CHANGES TO THE SPECIFICATIONS

CHANGES TO THE PLANS

REVISIONS
STEVEN M. CLOUSE WRC
PRIMARY CLARIFIER
REHABILITATION
PRIMARY CLARIFIER
PLAN AND SECTION

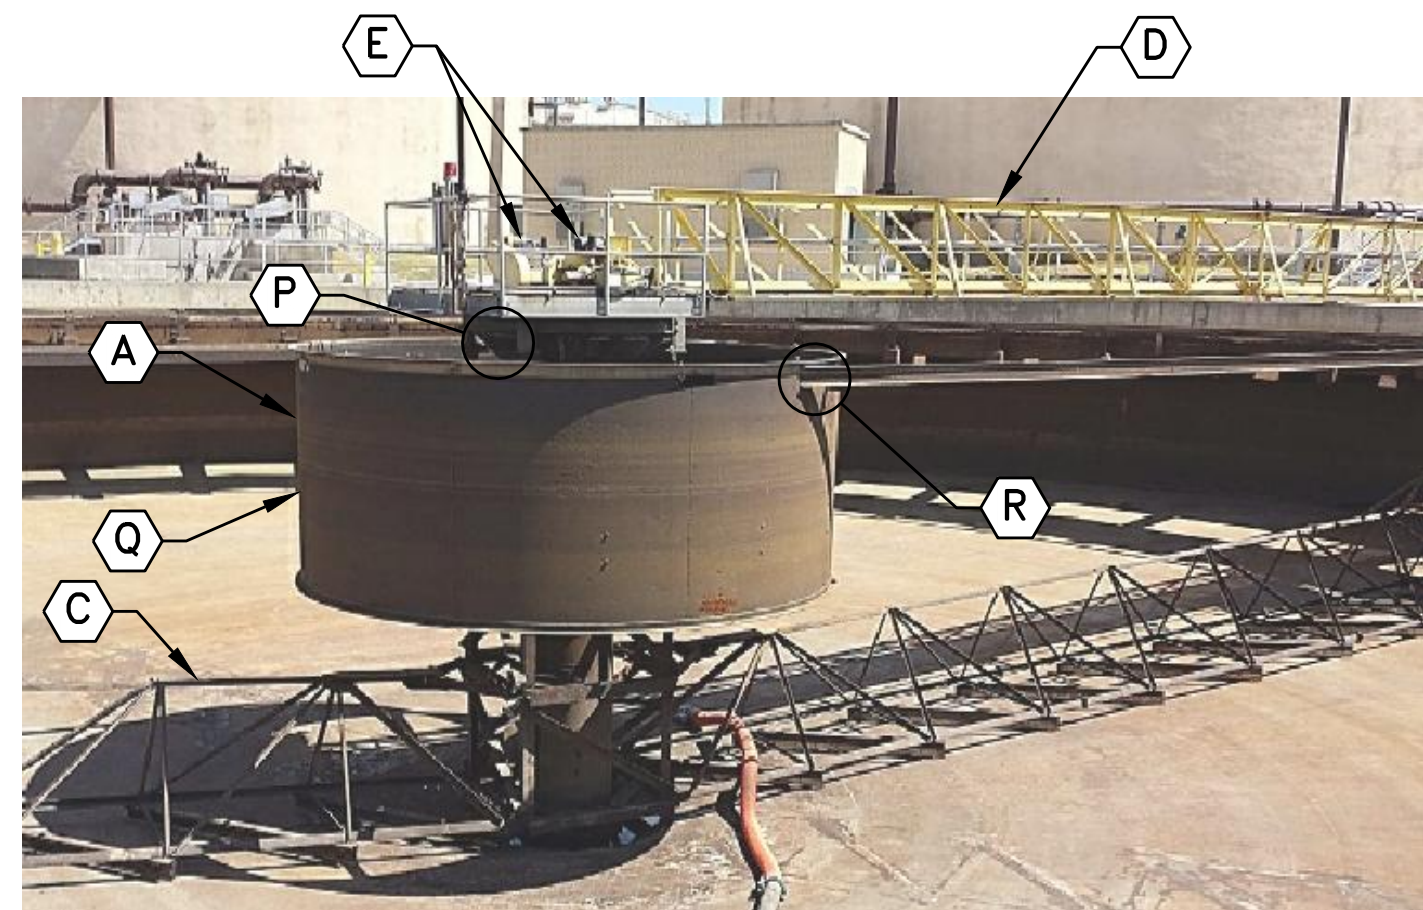
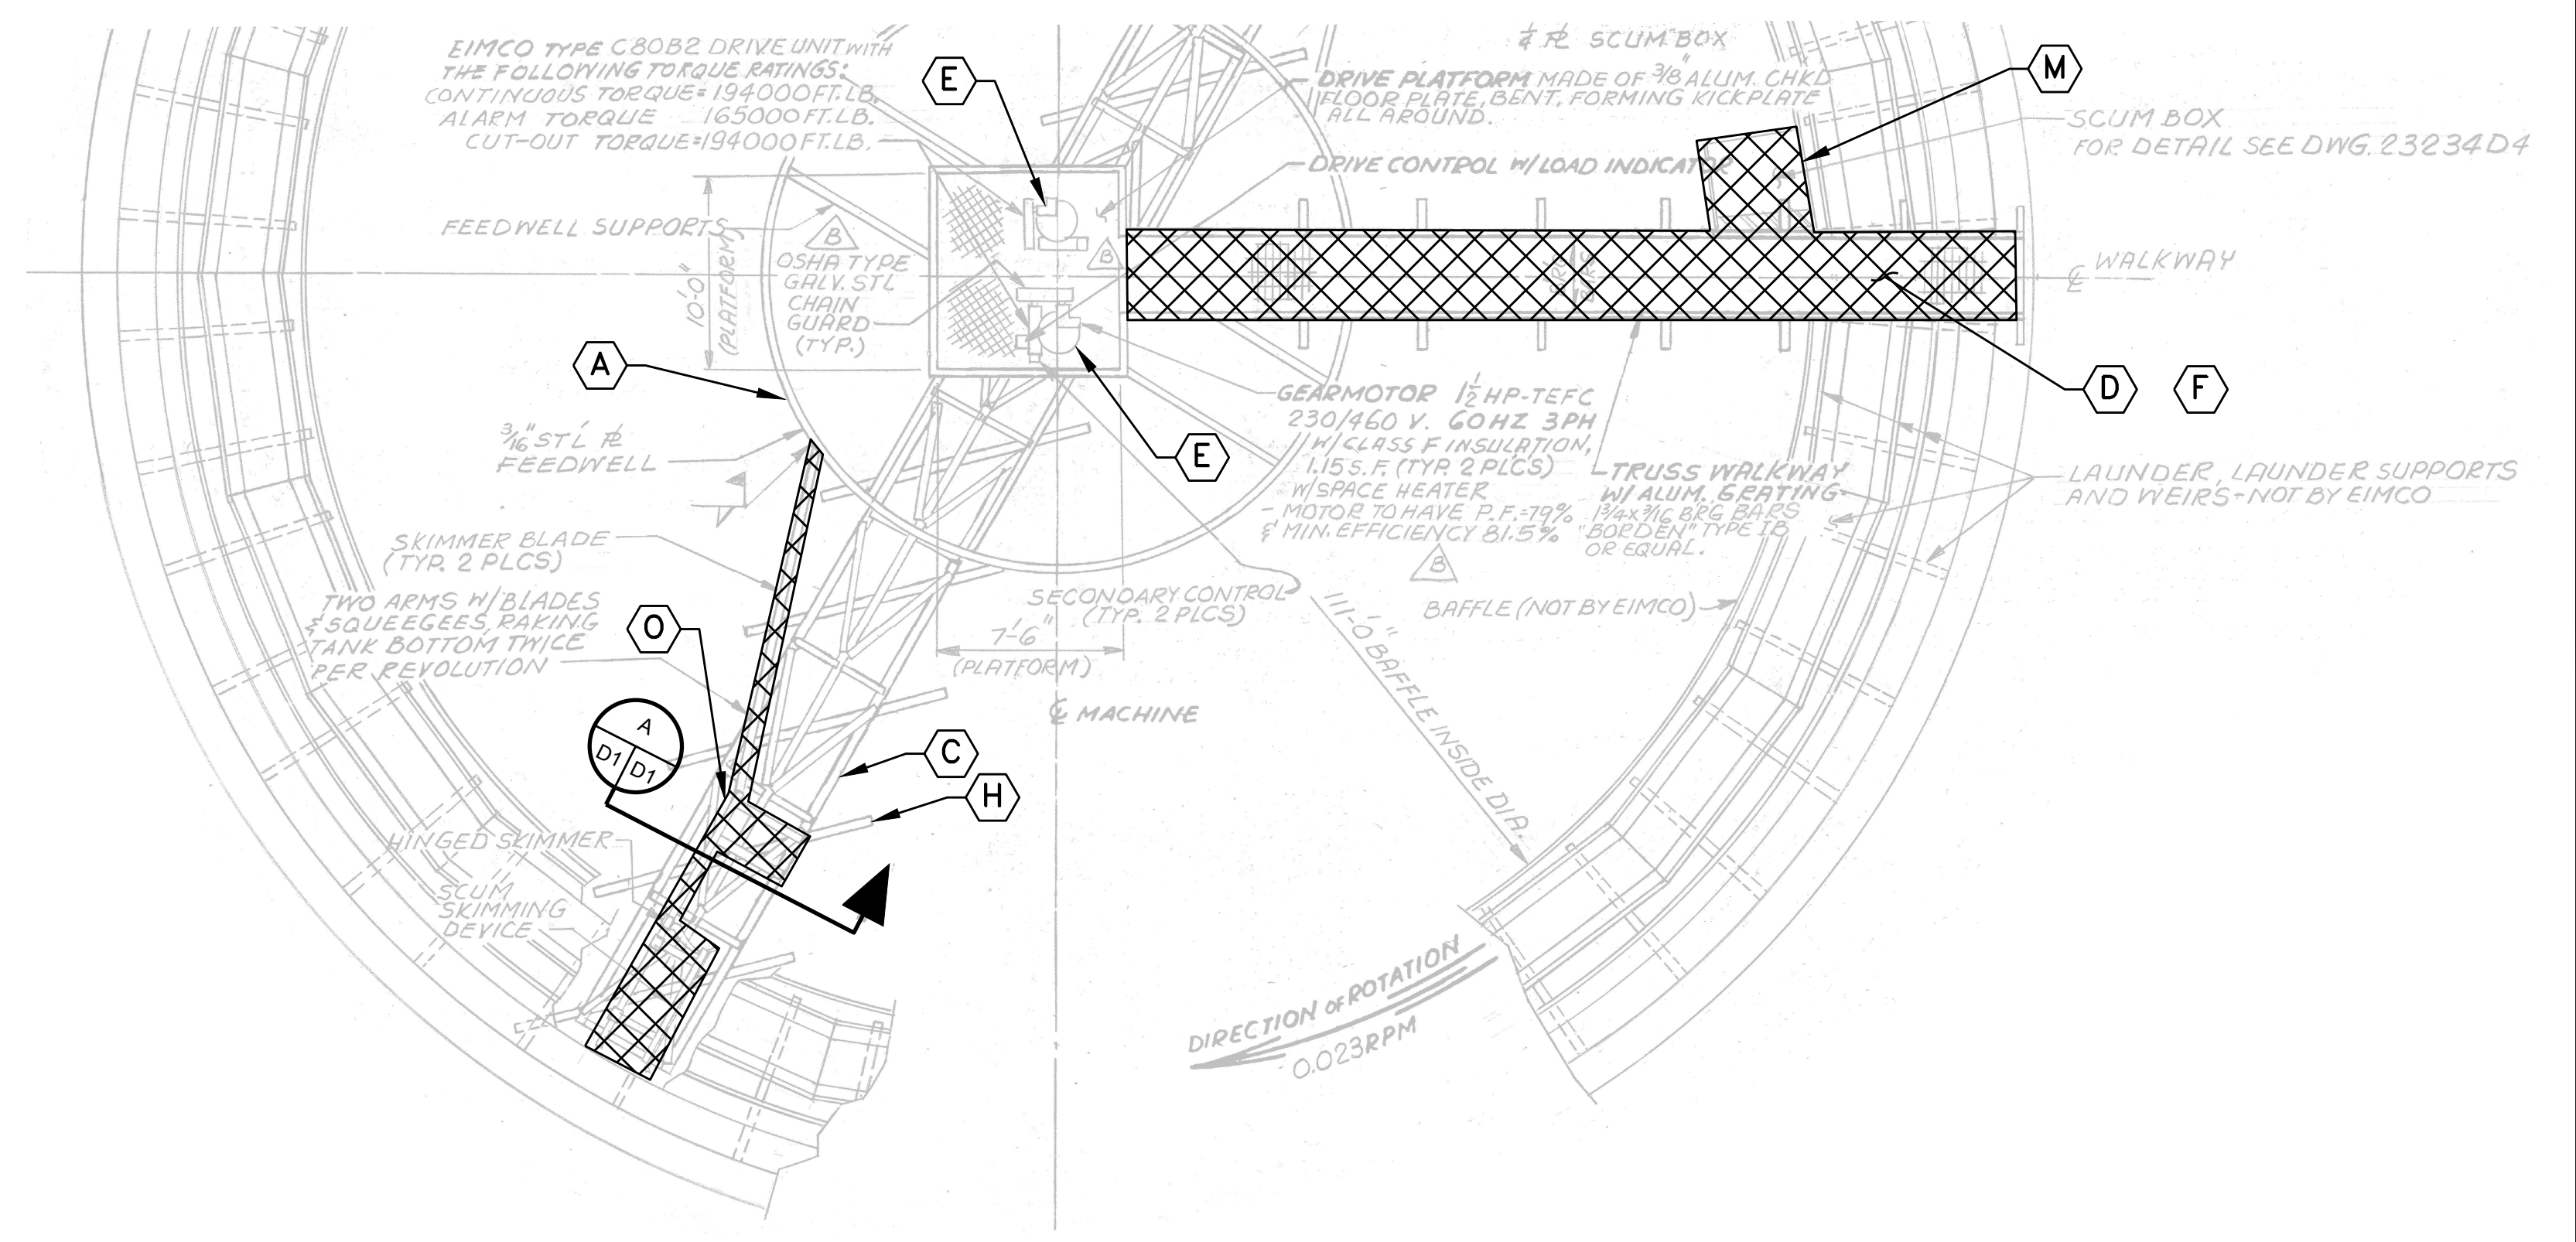
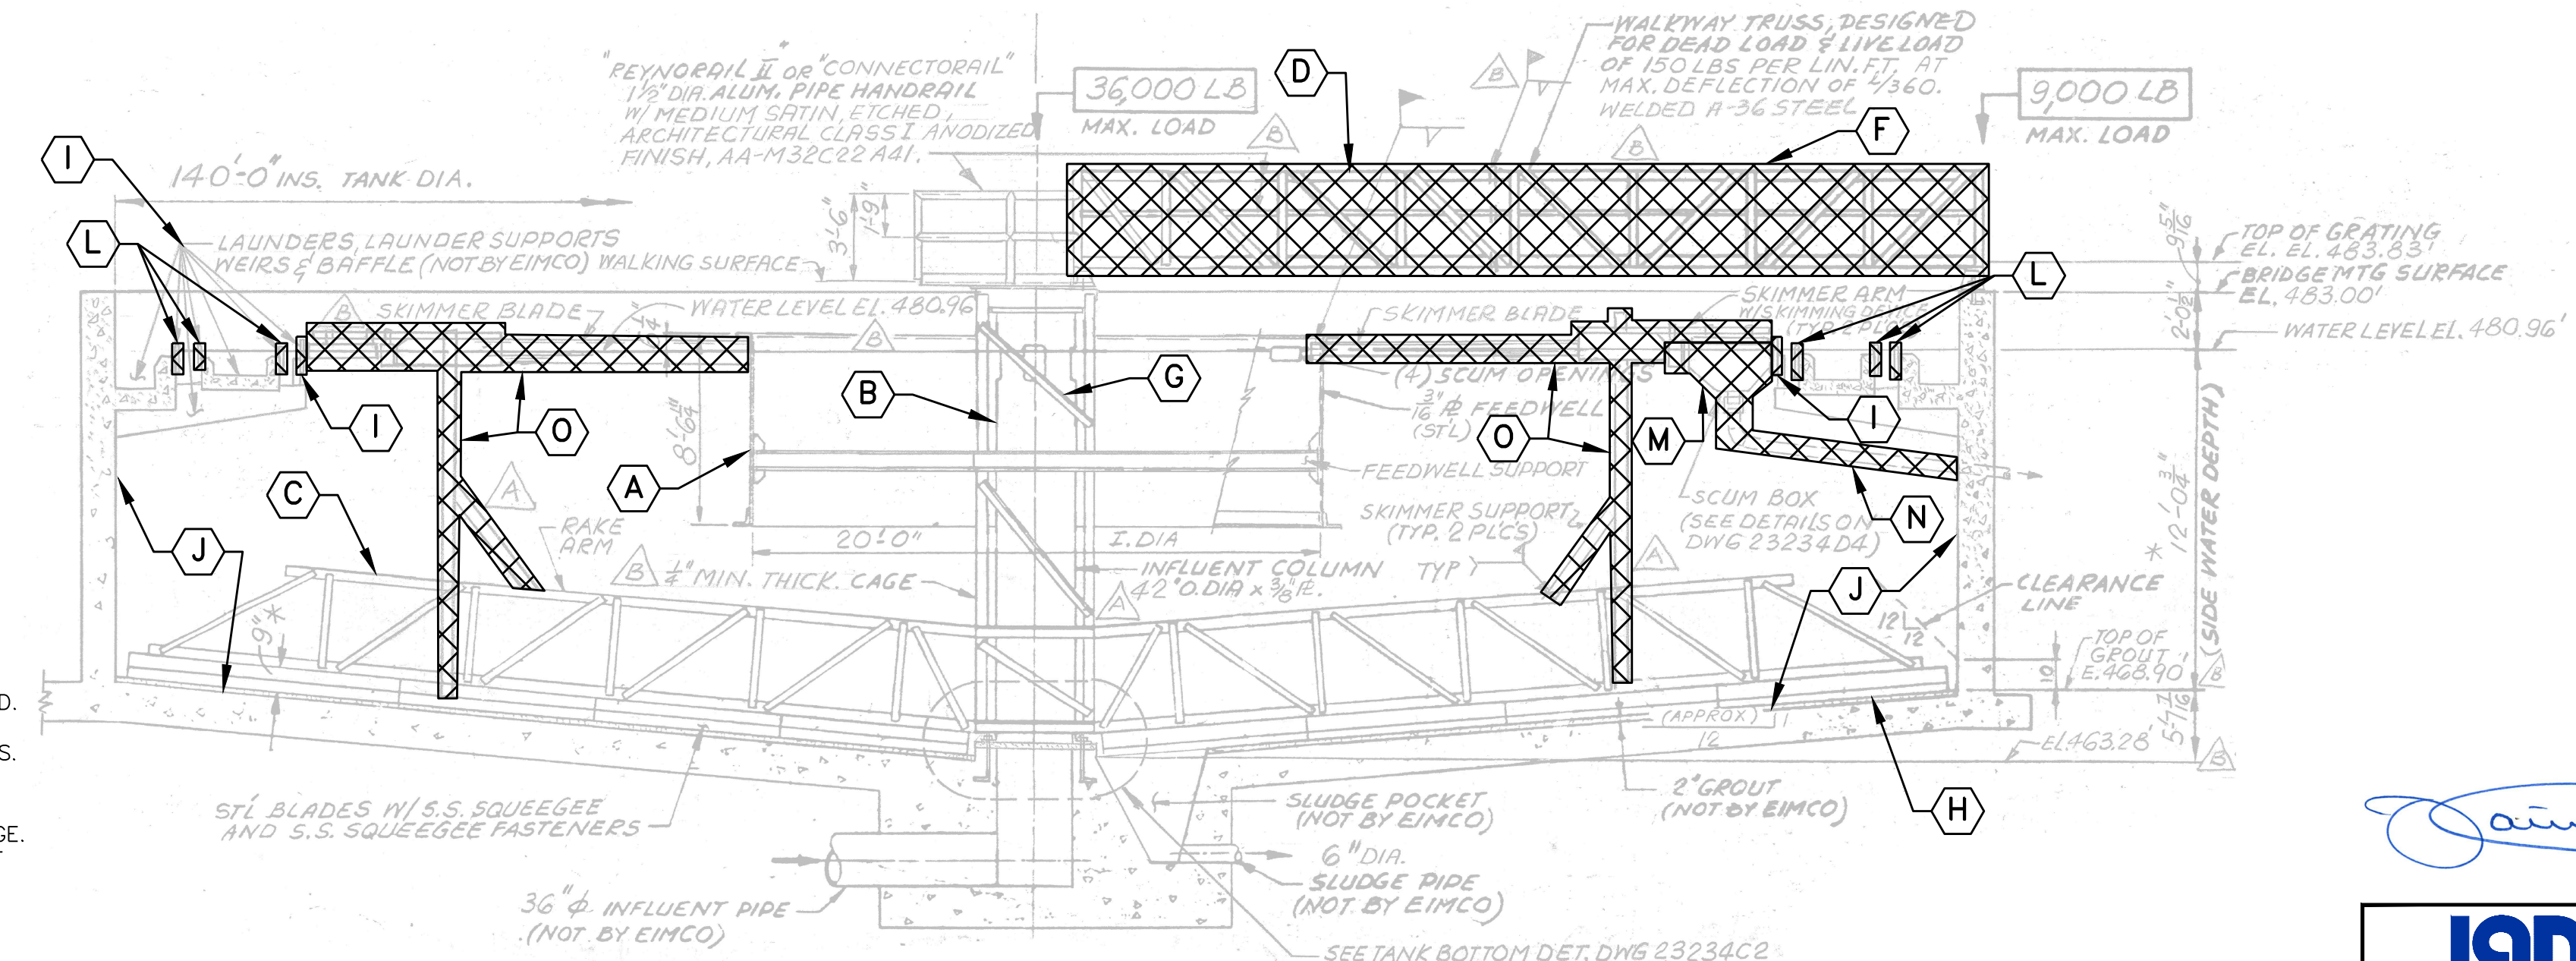
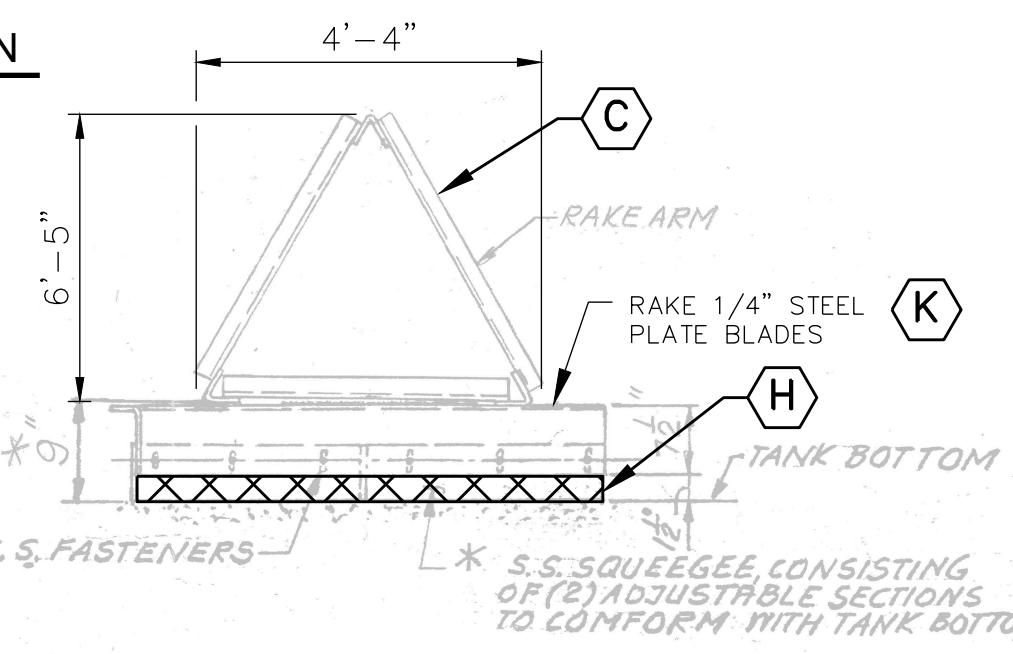
13. Keynote Q on sheet D-01 states to “remove and replace all C channels at center feedwells”. Sheet S-03, keynote D indicates that we are replacing the brackets, but doesn't mention replacing the C channels. Ovivo's scope only includes the brackets, and assumes the existing C channels are to be reused. Is this the case, or are we to replace all of the C channels with new?

Response: Only the brackets are being replaced. The C channels will be sandblasted, coated, and reused. Sheet D-01 was revised to clarify.

- (Q) REMOVE AND REPLACE ALL C CHANNEL ANGLE BRACKETS AT CENTER FEEDWELL. EXISTING C CHANNELS SHALL BE SAND BLASTED, COATED, AND REUSED.
- (R) SKIMMING ARM CONNECTIONS SHALL BE BOLTED FOR LEVELING, THEN WELDED. SEE SHEET M-02
